ARIZONA DEPARTMENT OF ENVIRONMENTAL QUALITY

February 11, 2016
FPU16-168

RE: WAFB – ADEQ Comments – ST012 - *Discussion toward extending Steam Enhanced Extraction (SEE), Enhanced Bioremediation (EBR) transition, Site ST012, Former Williams Air Force Base, Mesa, Arizona*

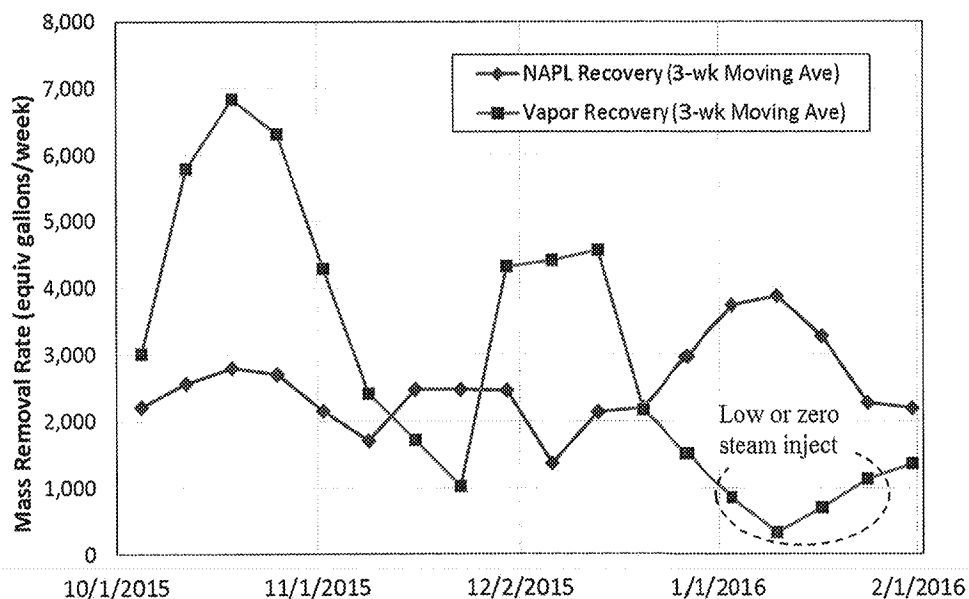
ADEQ asserts the mass removal criteria for transition to EBR has not been achieved.

Data from weekly progress reports were plotted to show the average gallons of NAPL recovered each week starting in October 2015. Equivalent gallons of NAPL recovered in the vapor phase were also plotted and the results are illustrated below. The NAPL recovery rate (red) has not decayed over the last four months, consistently averages over 2,000 gallons per week, and no indication of decay is evident. The vapor recovery rate (blue) illustrates a general decay; however, the rate dropped when the steam injection was lowered and ceased at the beginning of January. This drop in vapor recovery with steam cessation indicates significant mass continues to be recovered from within the TTZ by steam injection and that mass recovery rates continue to be related to steam injection.
